Subject: Comment Letter - 10CFR21 Report by MKW Power Systems; NEI Peebles (Portec) Voltage Regulators - Voltage Adjust Potentiometer

10CFR21 REPORTING OF DEFECTS  
AND NON-COMPLIANCE

COMPONENT: Chicago Telephone Supply (CTS), p/n 115R251A  
Voltage Adjust Potentiometer

SYSTEM: Diesel Generator control systems with NEI Peebles  
(Portec) Voltage Regulators

VOLTAGE ADJUST POTENTIOMETER "R4"  
NEI DRAWING A-01068  
CHICAGO TELEPHONE COMPANY POTENTIOMETER #115R251A

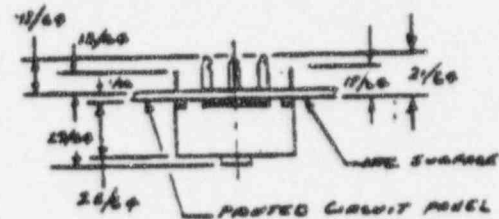
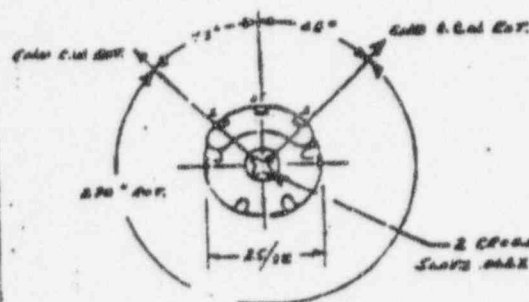
Microscopic examination of the potentiometer showed foreign material on the surface and edge of the stationary slip-ring under the wiper arm collar. The material on the edge was translucent/white-ish and appeared to be a lubricant. The material on the surface was blackish with some white flakes. It is postulated that the lubricate accumulated contaminants and/or dried on the surface. The total amount of foreign material is very small.

- 1) FP&L is in the process of updating their voltage regulators with the Maury potentiometer. Other users should be aware of this possible problem and monitor their EDG output voltage for unstable output during routine testing. Replacement of the potentiometer is dependent upon monitoring/testing. Immediate response to this notification does not appear to be necessary as the majority of the in-service voltage regulators have been operating without incident for approximately 15-20 years.

- 2) The potentiometer is soldered to a circuit board within the voltage regulator assembly; therefore, field modification is not recommended. For replacement of the potentiometer, it is recommended that the regulator be returned to NEI (either directly or through MKW Power Systems) where proper testing can be performed before the regulator is returned to the customer. Contact MKW Parts Department for assistance.

"R4" REPLACEMENT  
MAURY #50-M-123-251

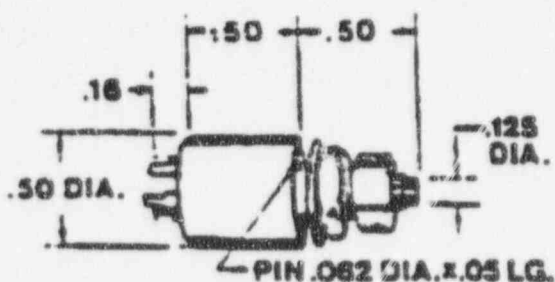
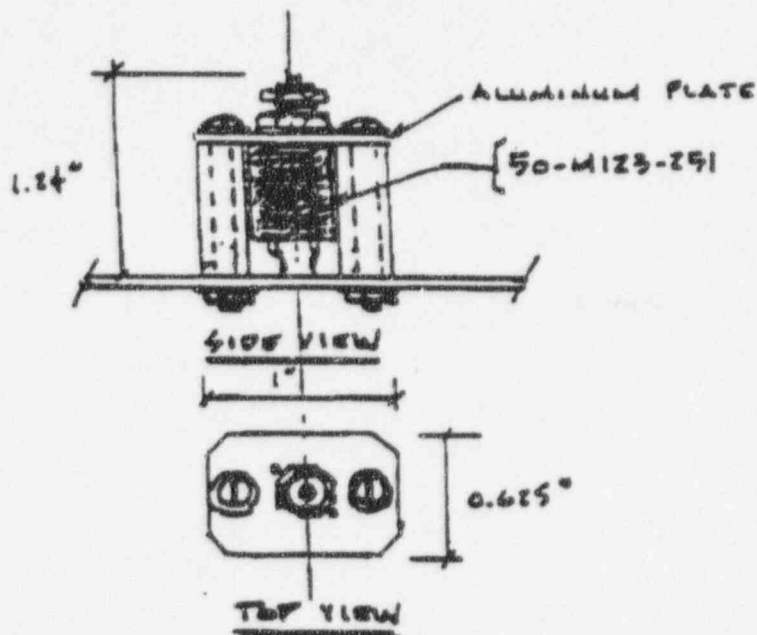
REPLACEMENT FOR 115K251A USED IN VOLTAGE  
REGULATOR 72-13000-100 AS RESISTOR R4.

If a regulator is to be upgraded, we would also recommend replacement of the R5 (stability) potentiometer which is the same type as the R4 potentiometer except it is 100 ohms. This is strictly optional, no voltage regulator operability problems exist with the R5 potentiometer. The R5 potentiometer is CTS p/n 115R101A (NEI p/n 01070) and its replacement is Maury p/n 50-M123-101.
